AUDIT OF USAID/PAKISTAN'S ACTIVITIES RELATED TO JINNAH POST GRADUATE MEDICAL CENTER AND JACOBABAD INSTITUTE OF MEDICAL SCIENCES

AUDIT REPORT NO. G-391-15-002-P
JANUARY 29, 2015

SUBJECT: Audit of USAID/Pakistan's Activities Related to Jinnah Post Graduate Medical Center and Jacobabad Institute of Medical Sciences
(Report No. G-391-15-002-P)

Pictures of Deficiencies in the OB/GYN Wing of Karachi Medical Center
(Photos by OIG, February 26, 2014)

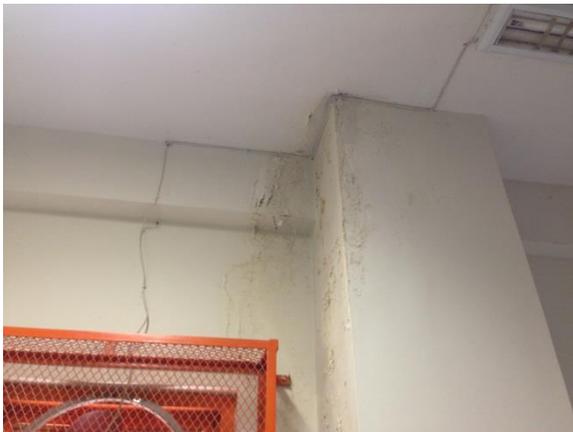
Poorly mounted electrical fittings may be dangerous for users.
